**Addendum No. 1**

Contract No.: DA00388

*Construction of Two (2) Open-Air Passenger Shelters, One (1) Bathroom Addition,  
Two (2) New Parking Areas and Existing Parking Area Asphalt Overlay*

**ADDENDUM NO. 1****DATE: 9-11-2017****TO: ALL BIDDERS****RE: NCDOT HATTERAS ISLAND PASSENGER TERMINAL**  
**SCO ID #17-17067-01A**  
Project No. 2016-26

SCALE	1/4" = 1'-0"	DRAWING NO.	A5.1
DRAWN	MCZ		
CHECKED	JKF		
DATE	5-1-2017		
PROJECT NO.	2016-26

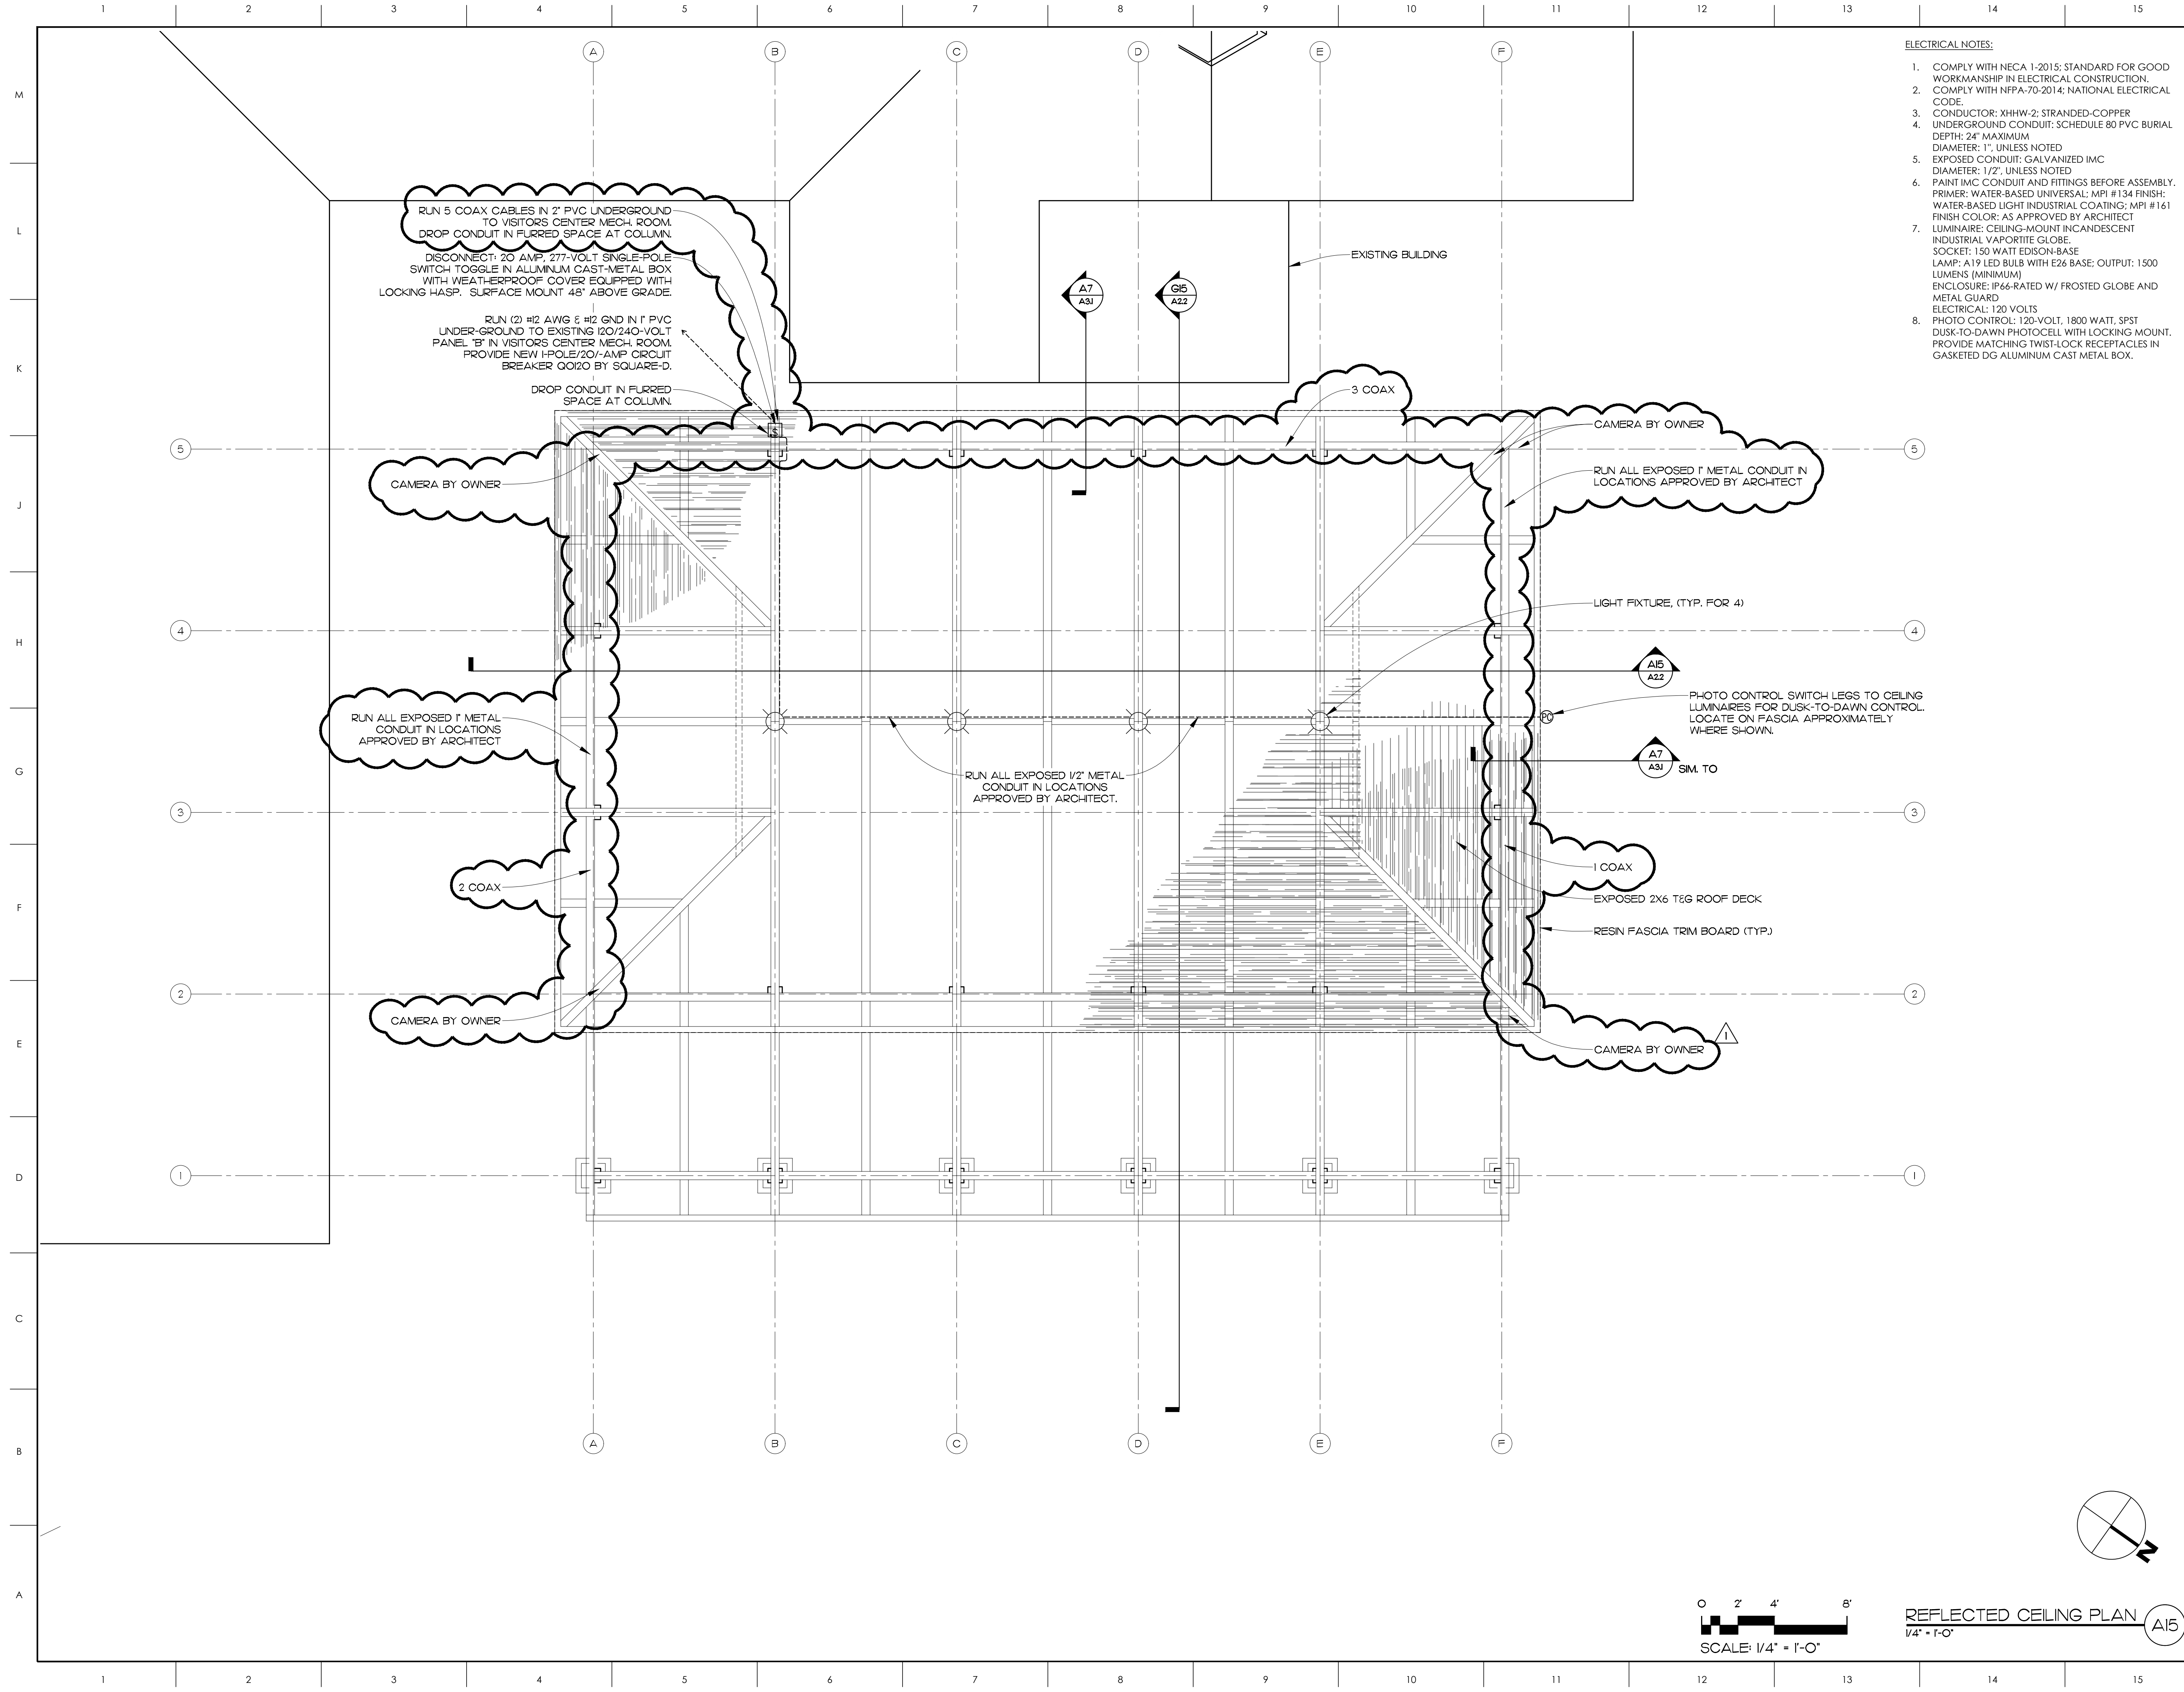
7. Drawing A1.1; edited concrete apron and walkway to gangway, edited rope fence location
8. Drawing A5.1; edited to include conduit and coax cable for security cameras

SCALE	1" = 30'	DRAWING NO.	C102
DRAWN	EDM		
CHECKED	WEL		
DATE	9-7-2017		
PROJECT NO.	I188360P

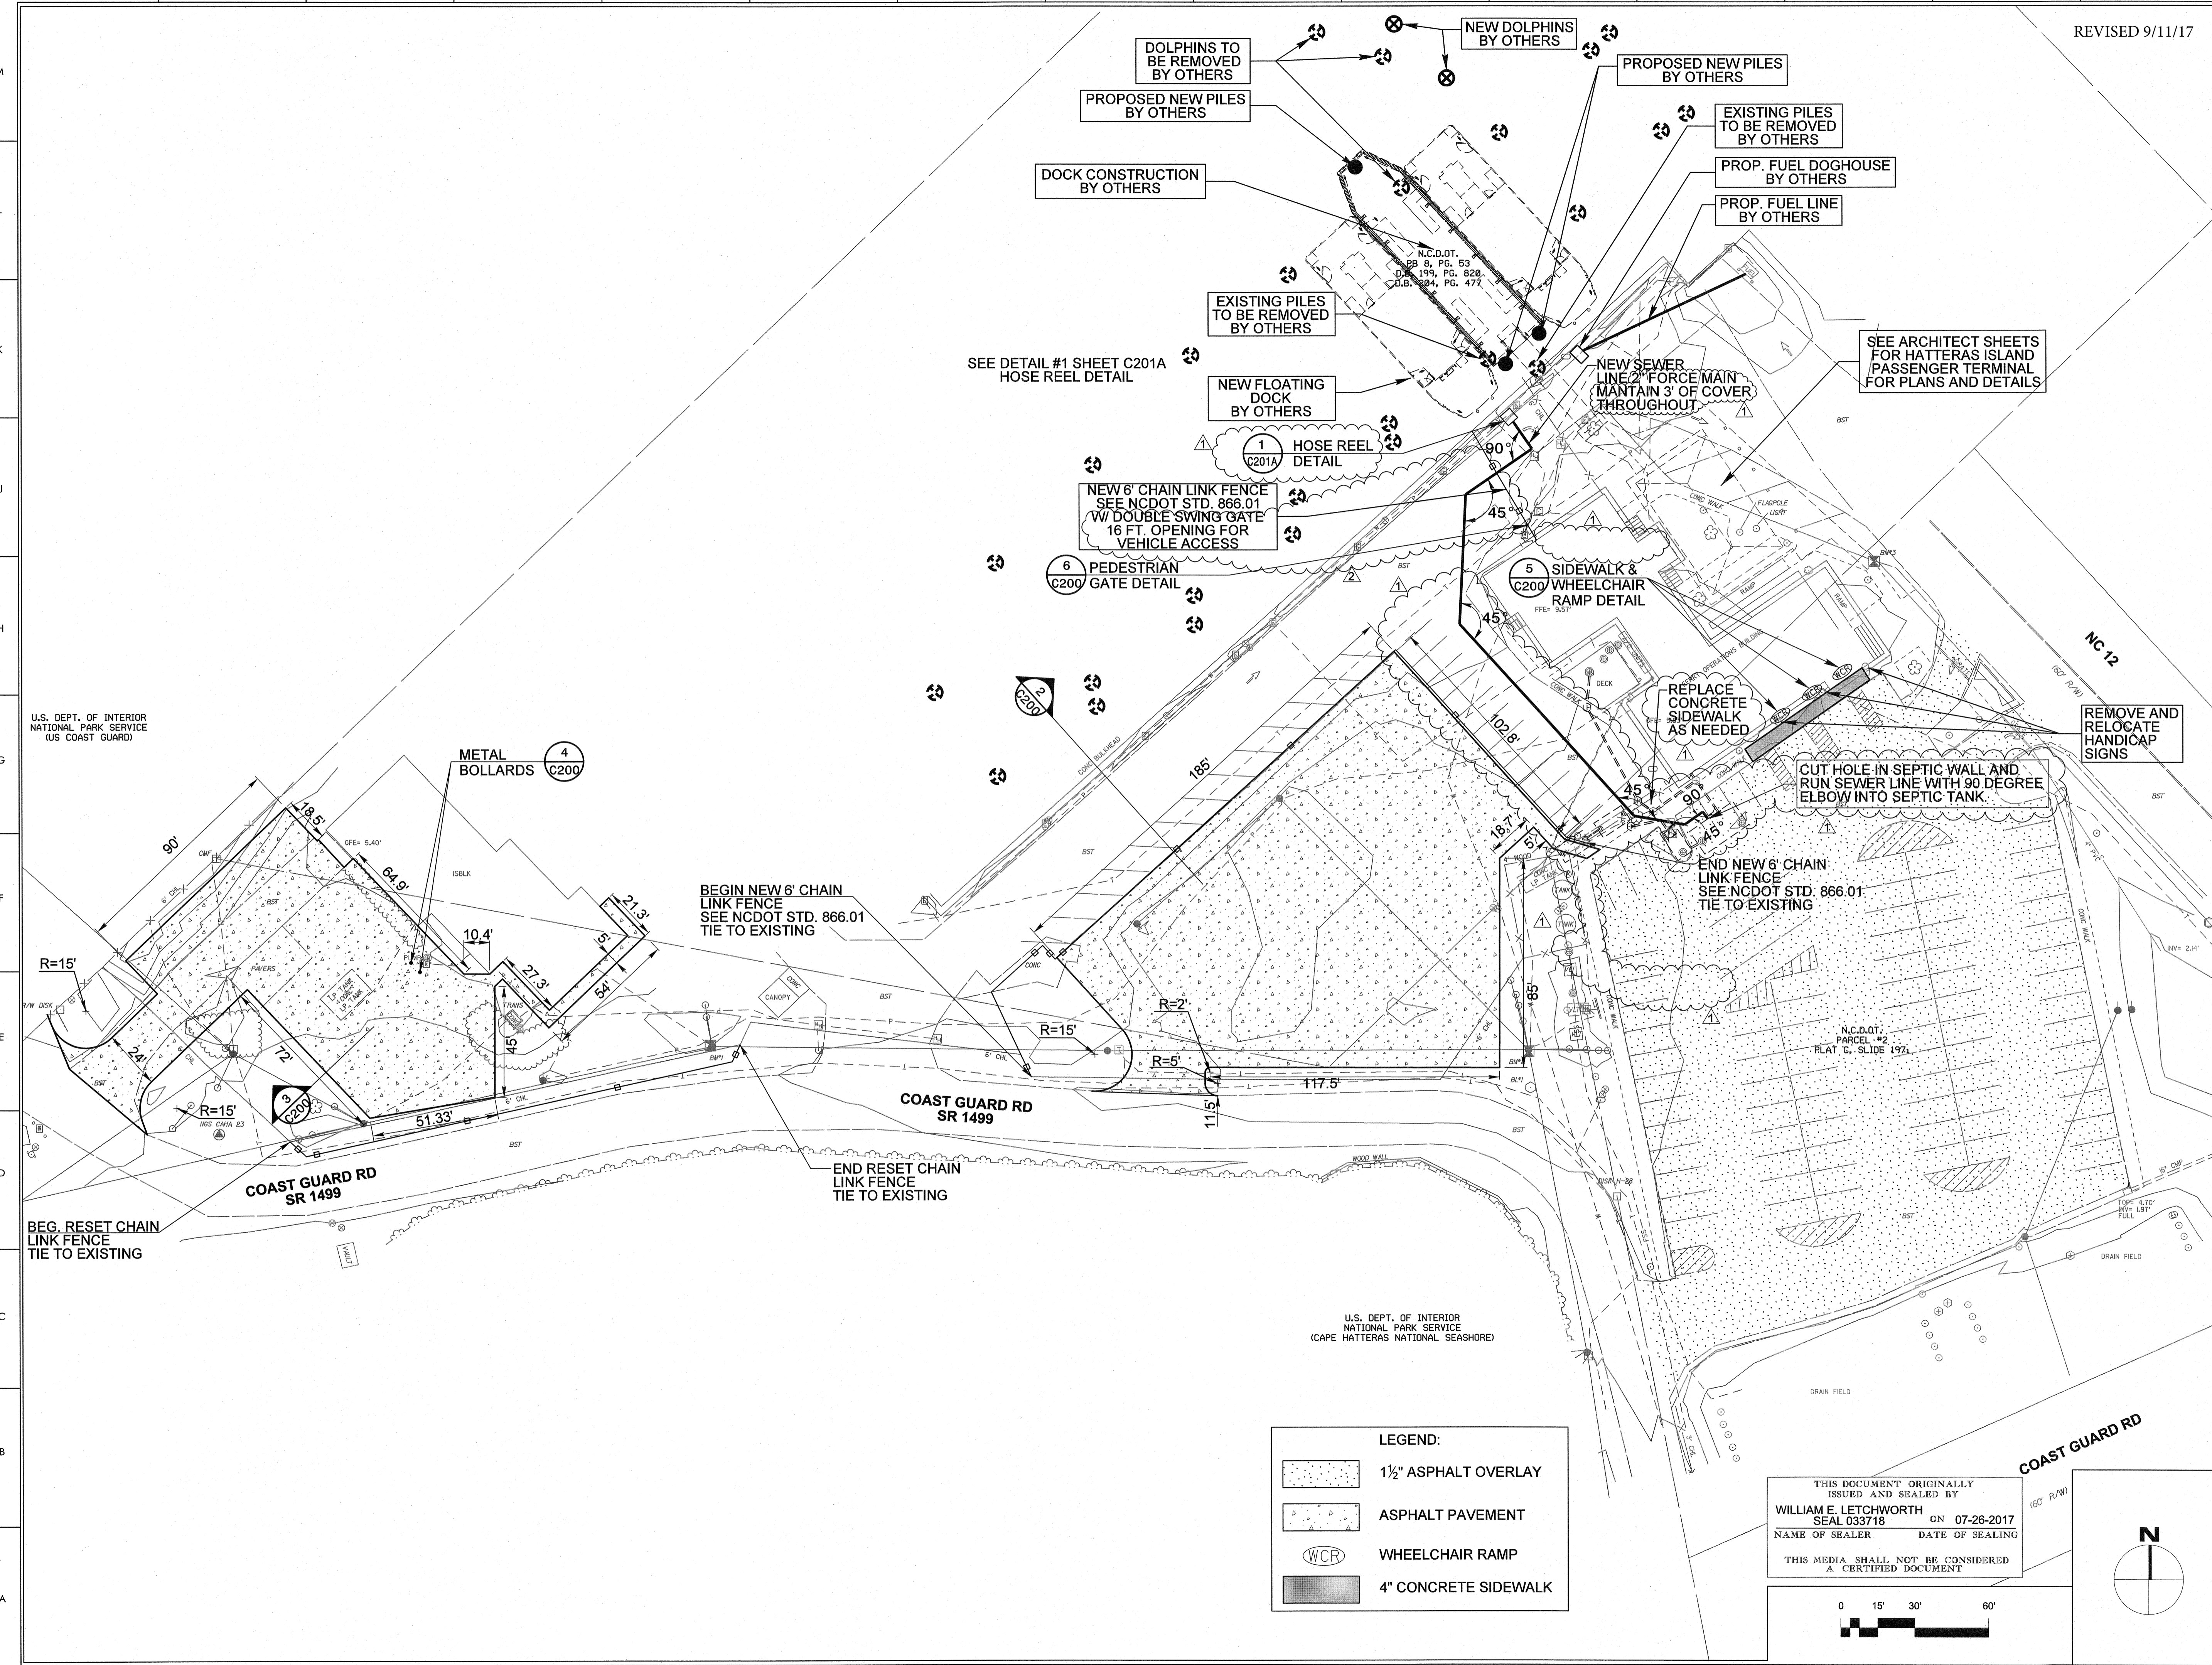
3. Drawing C102; Revised location and connections for new sewer line, revised configuration for chain link fence adjacent to terminal building, revised background detail to more accurately reflect new gangway location and terminal configuration, new drawing is attached

## ONSITE CONCRETE WASHOUT STRUCTURE WITH LINER

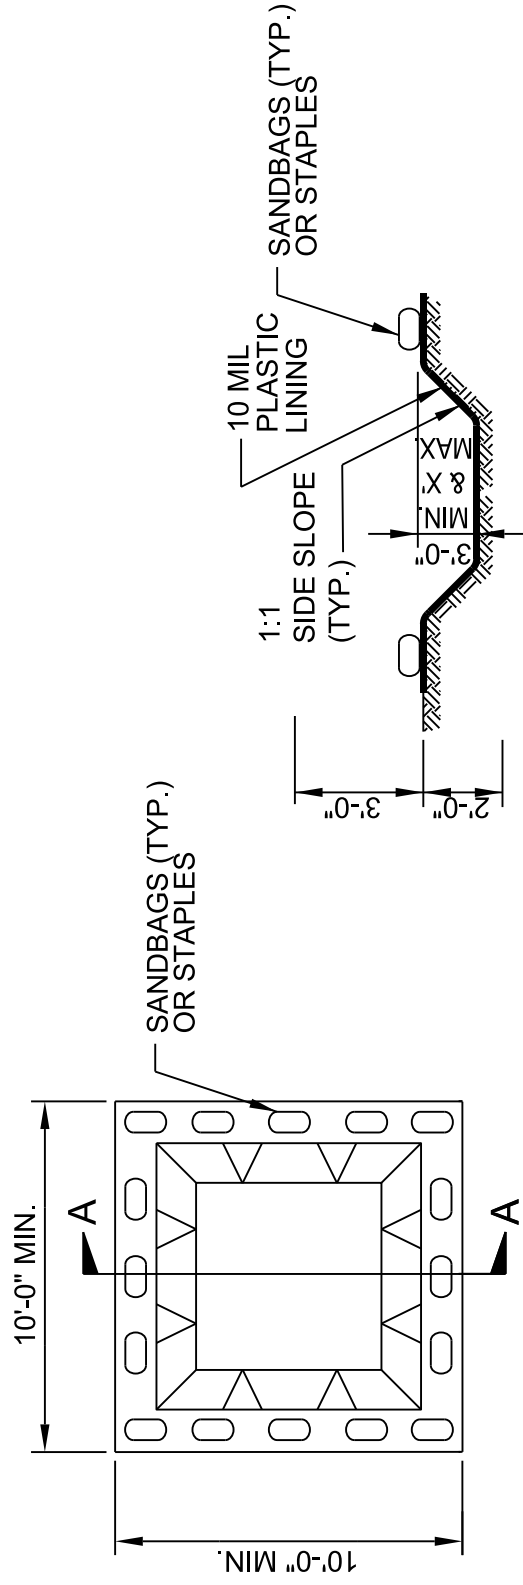
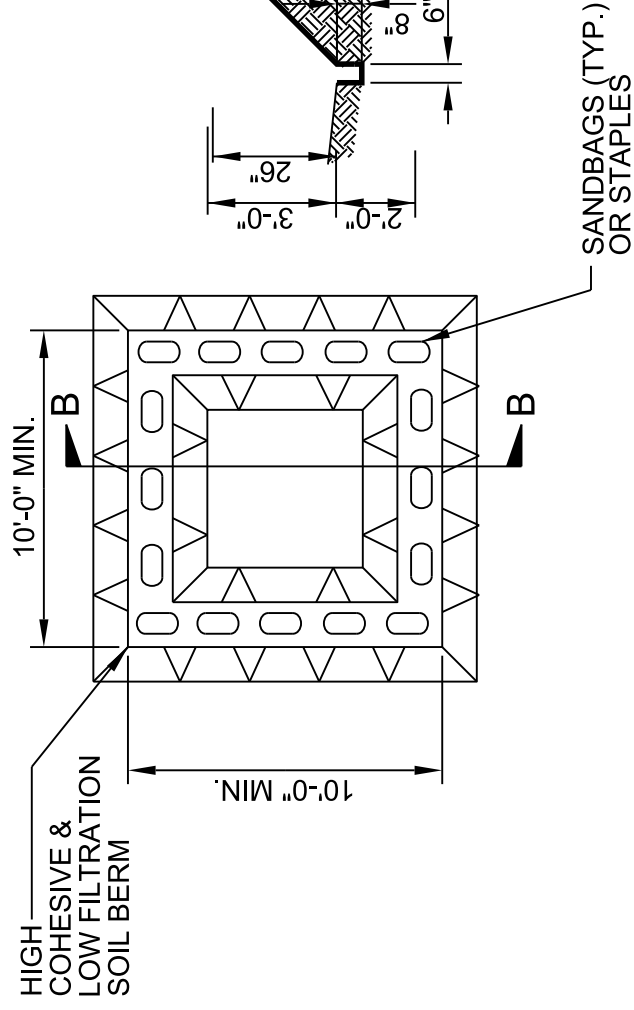
**“Concrete Washout Structure Detail”** has been included, for your reference.
